Conduit Schedule: 08.13.2019

09.06.2019: Conduit Asbuilts for Gas, Power & Communication

As-Builts: 10.11.2019
Water Completed - Highlighted Blue
Sewer Completed - Highlighted Green

As-Builts: 11.14.2019
Drainage Completed Except for the Following:
SS2 Tops Remaining to PIP: A3.1, A3.2, A3.3, E2, C4.1, C3.1 (G1 & E1 must remain in place until turn lanes are completed, then solid tops can be installed).

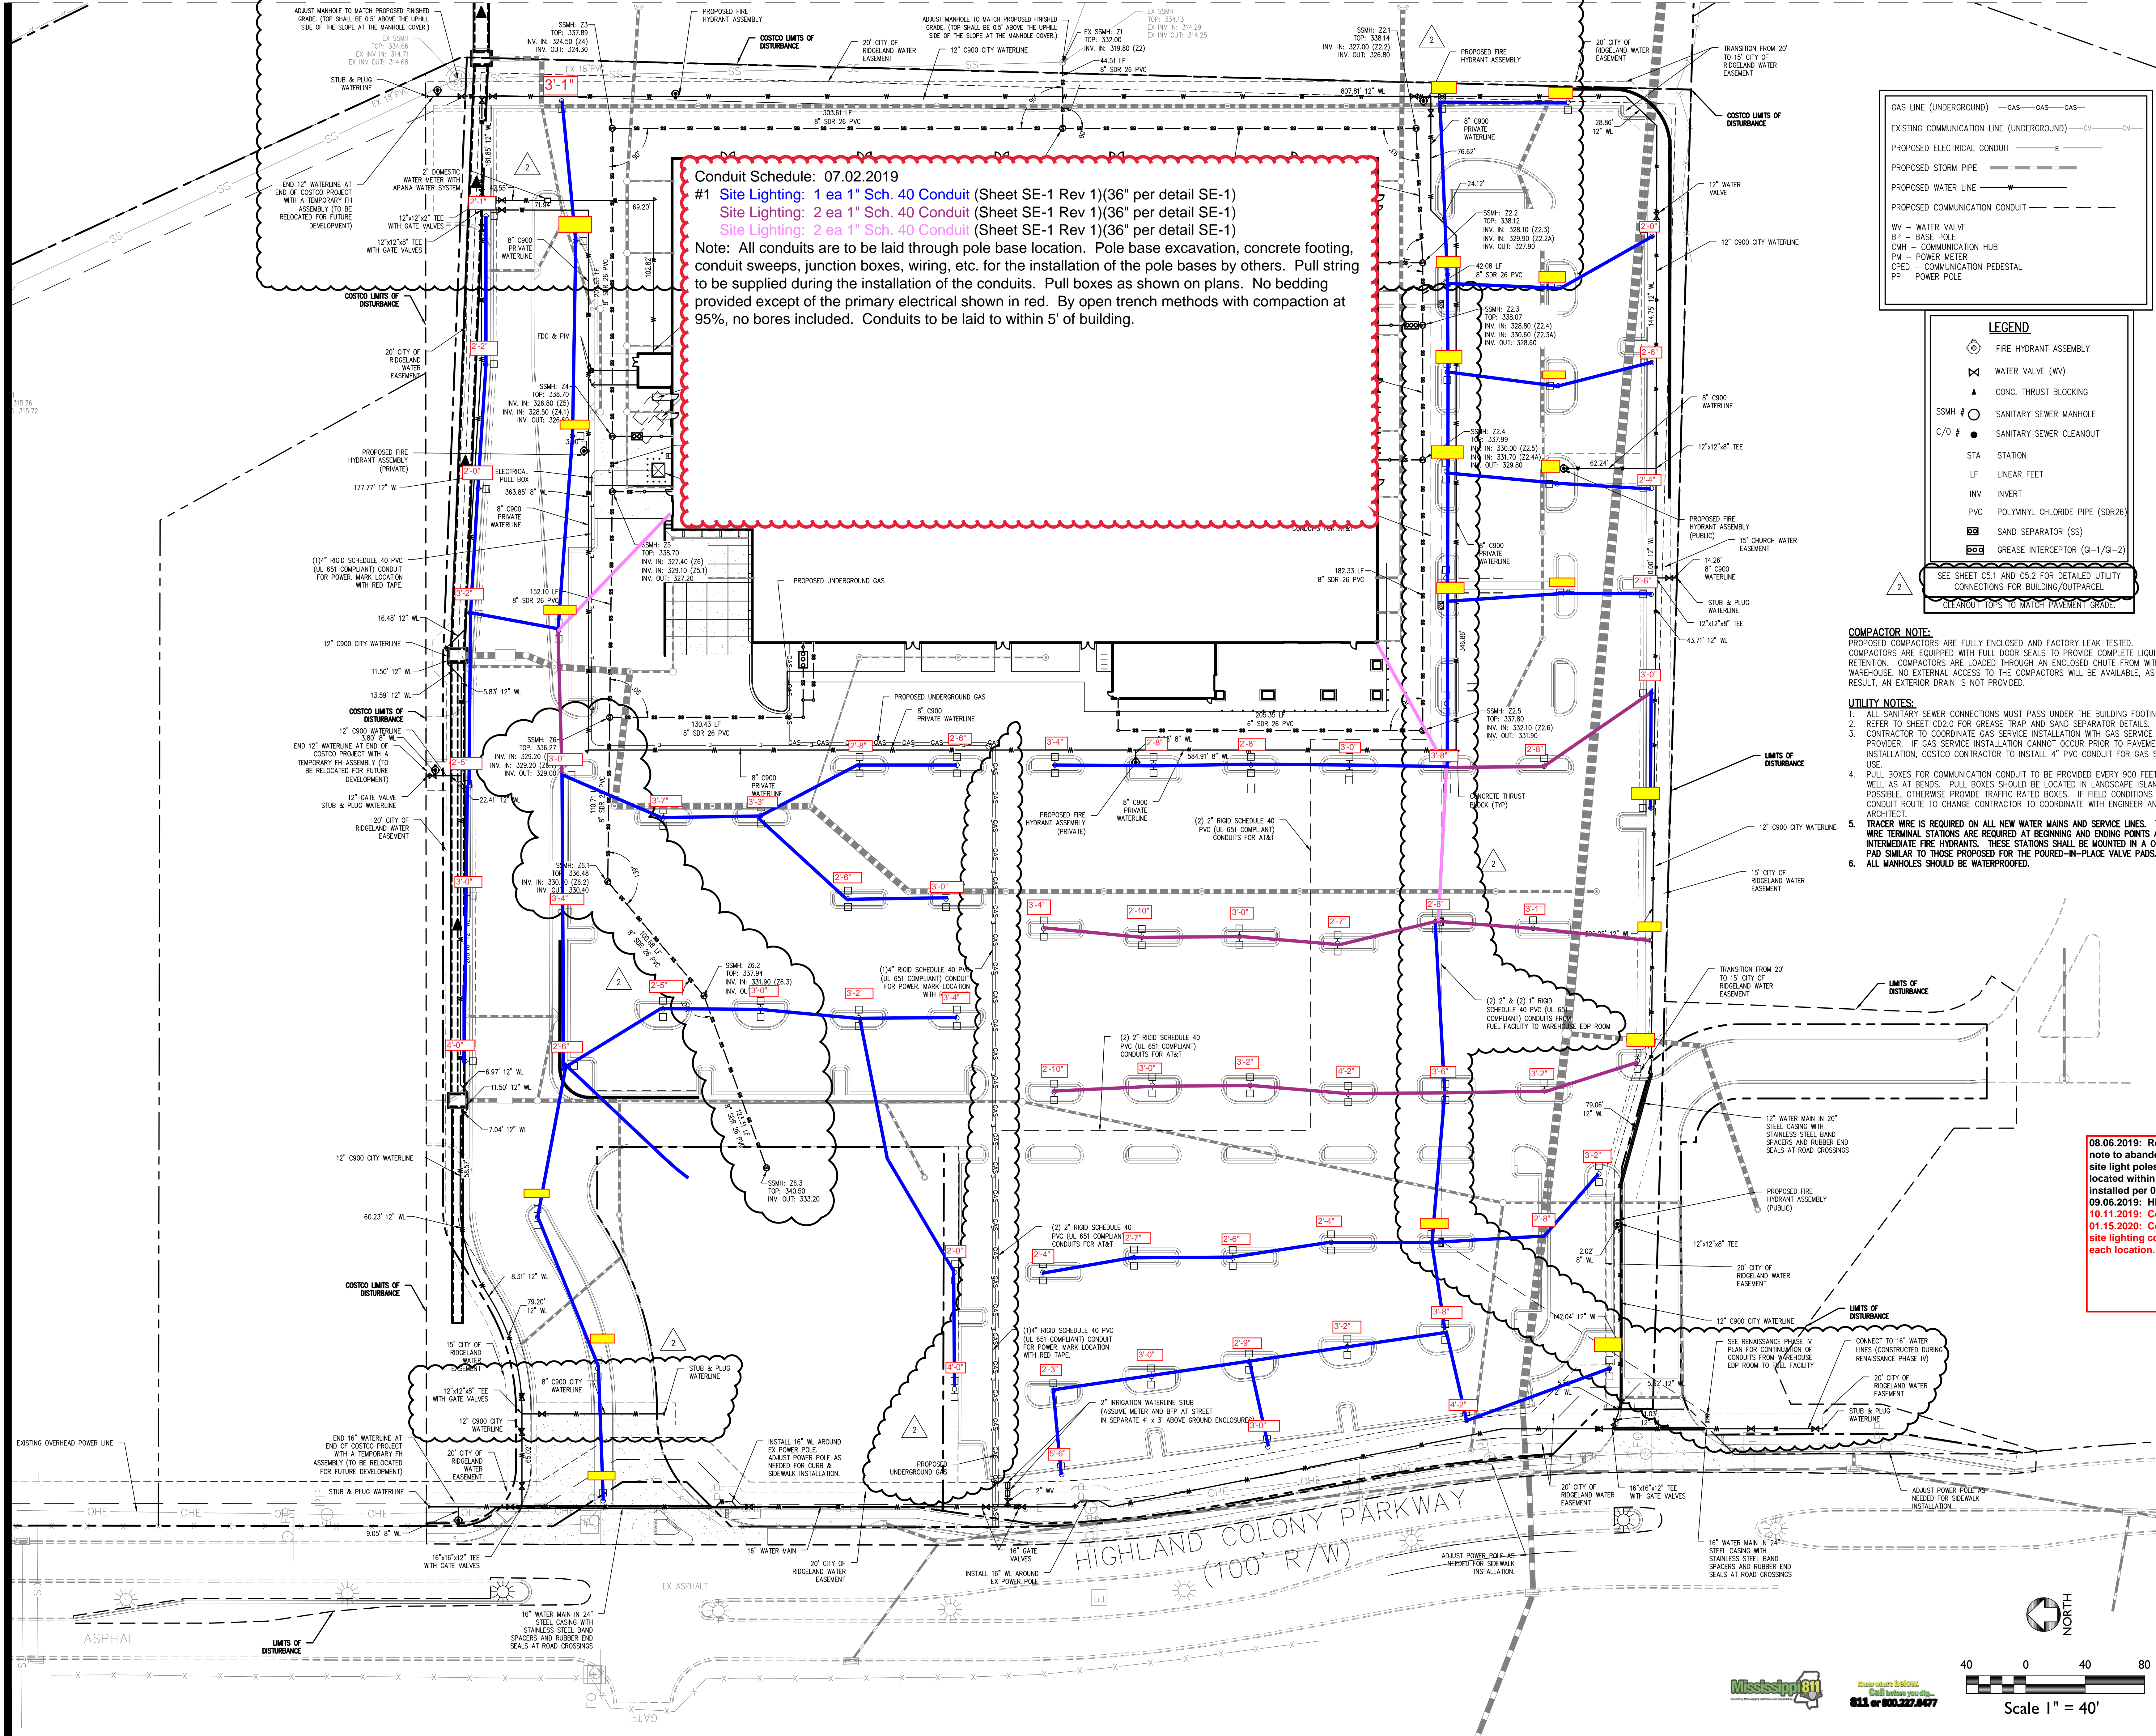
AT&T pull box located in Asphalt pavement due to size required and location of Costco pull box for Fuel Station Conduit.

Electrical Pull Box Behind BOC in Greenspace. Lid to be Tier 15. (08.06.2019)

180' from 36" radius 90 bend to pull box (09.17.2019)

267' from pull box to 36" radius 90 bend (09.17.2019)

4" Long Radius 90 Sweep installed on Gas Conduit.

Electric Pull Box lid to be Tier 22. (08.06.2019)

08.06.2019: Revision 4 - Added pull box location and notes. Added note to abandon orange comm. conduit run in place. Per Julie Miller, site light poles can be field adjusted due to island having a pull box located within the same island or location. Site Lighting Conduits installed per 09.20.2018 Light Pole Locations.

09.17.2019: Updated notes on primary power conduits.

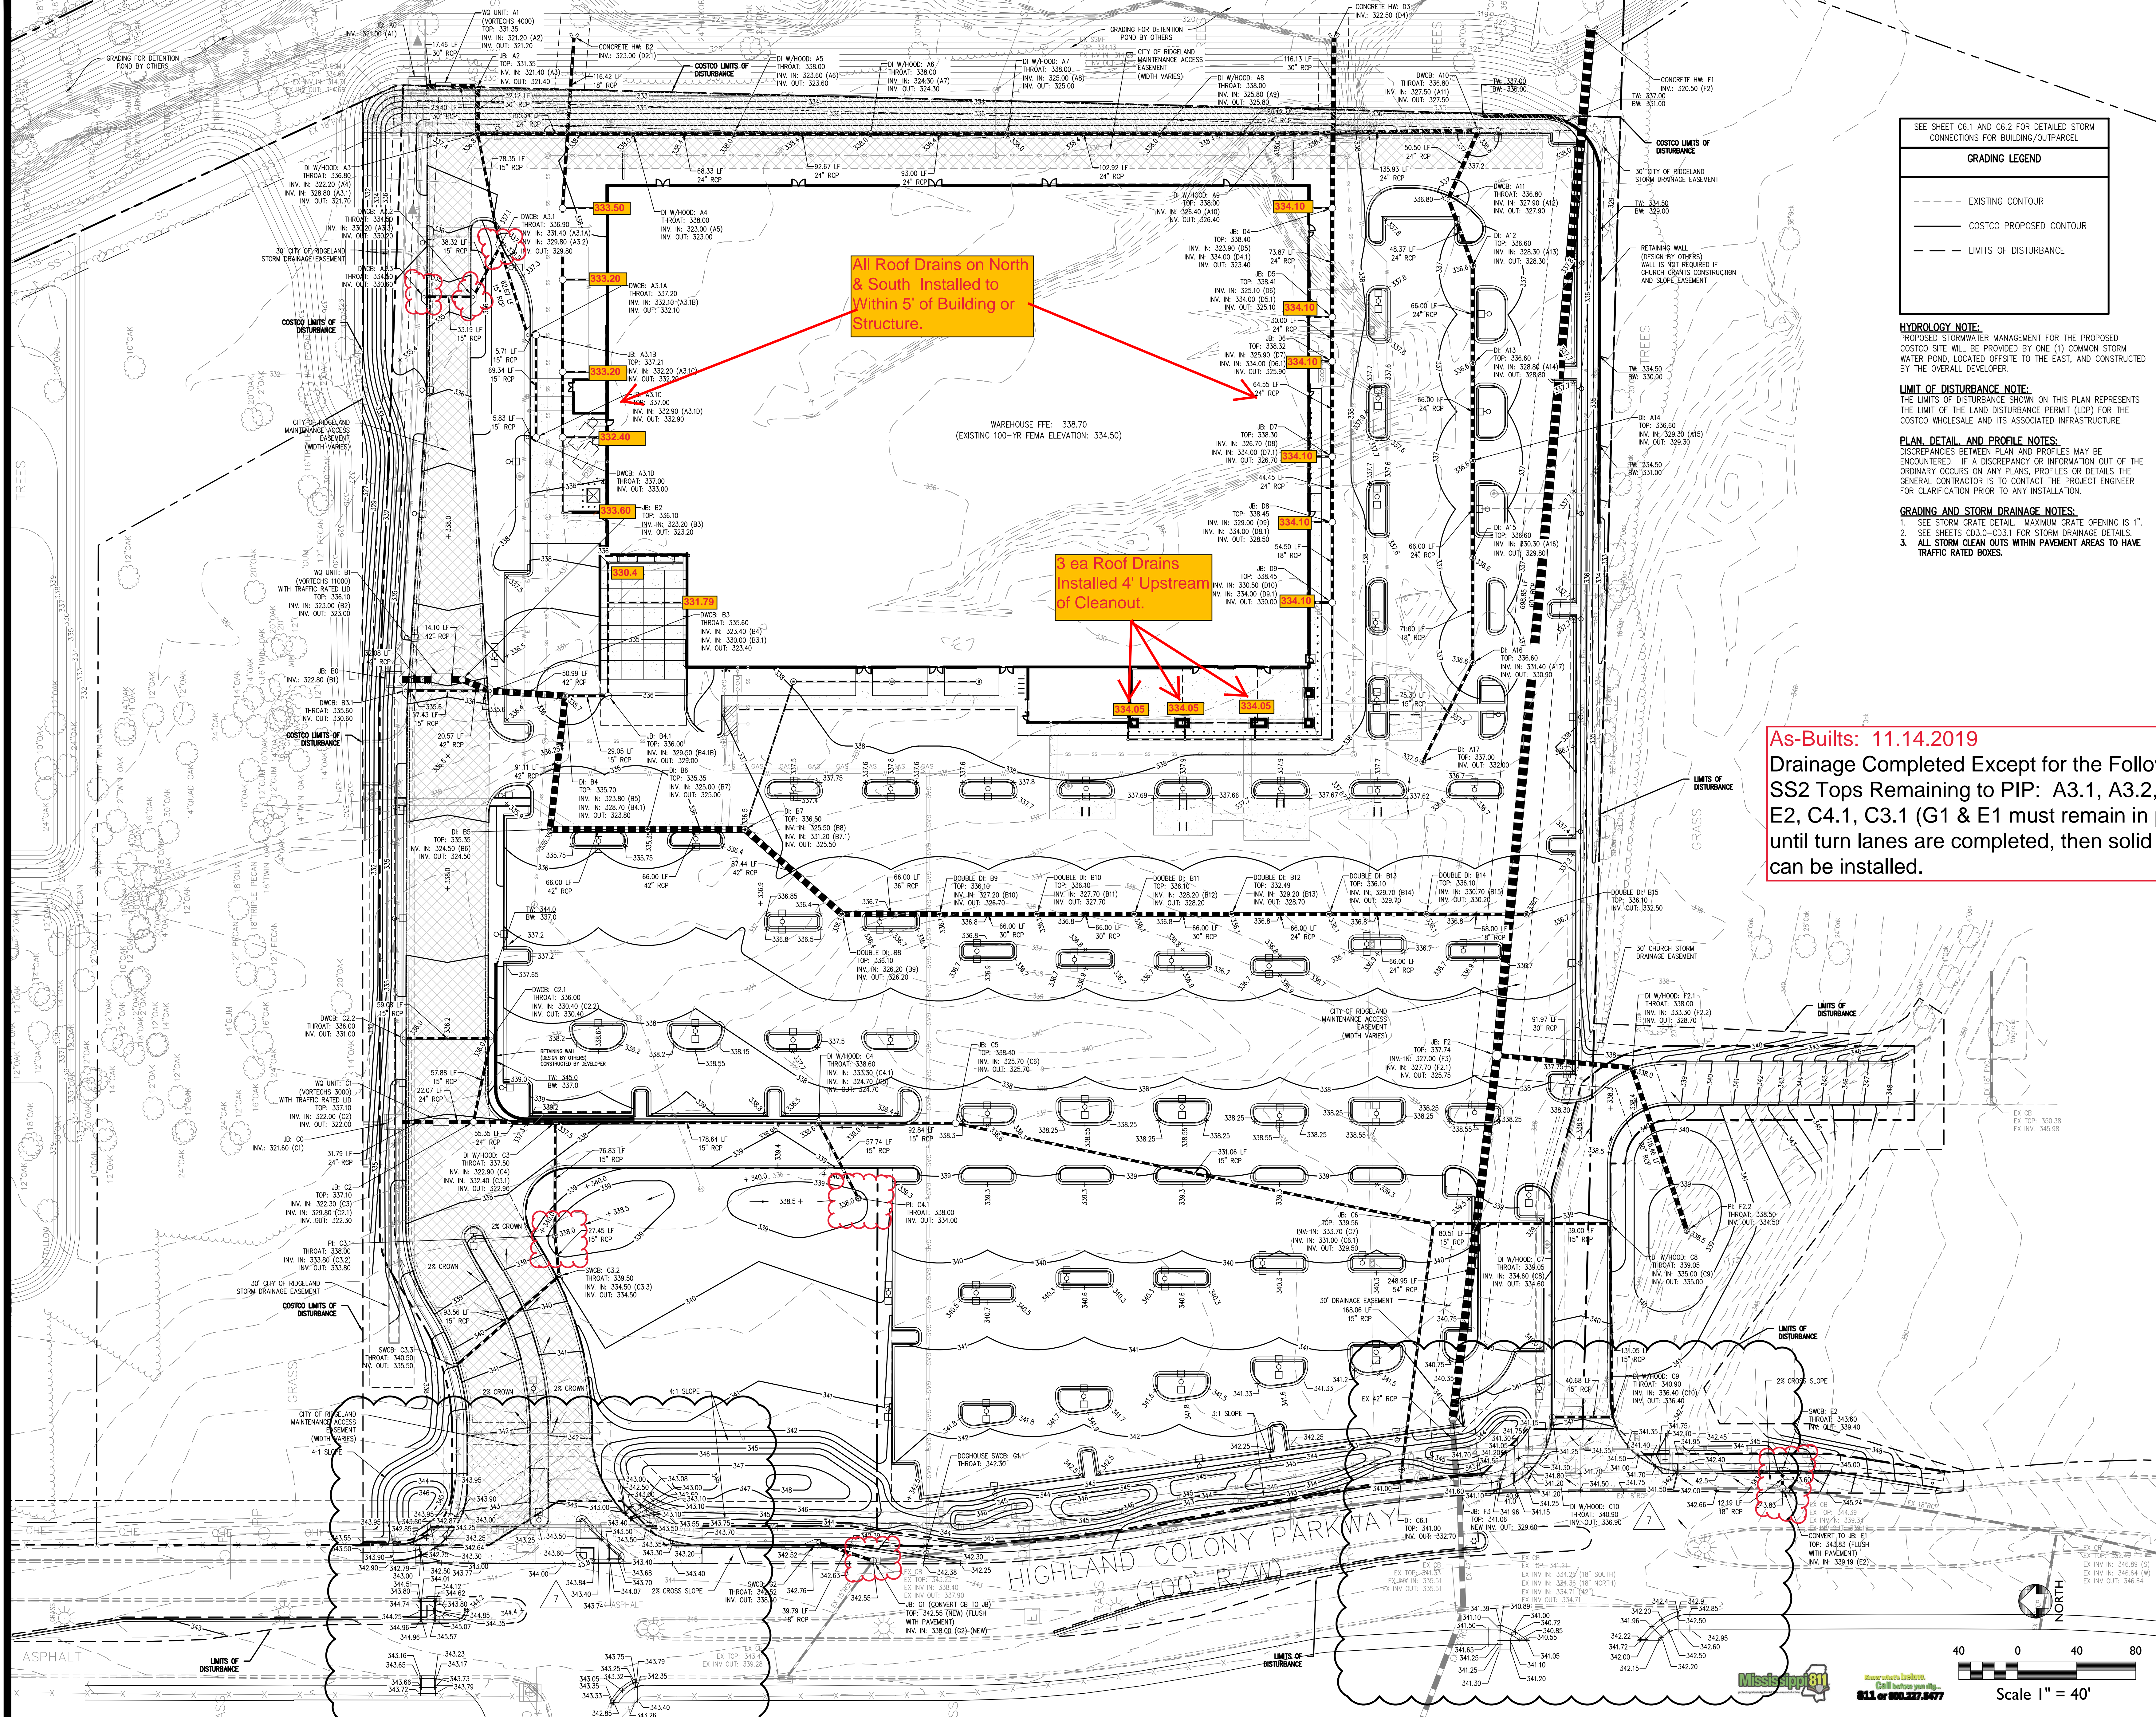
All Roof Drains on North & South Installed to Within 5' of Building or Structure.

3 ea Roof Drains Installed 4' Upstream of Cleanout.
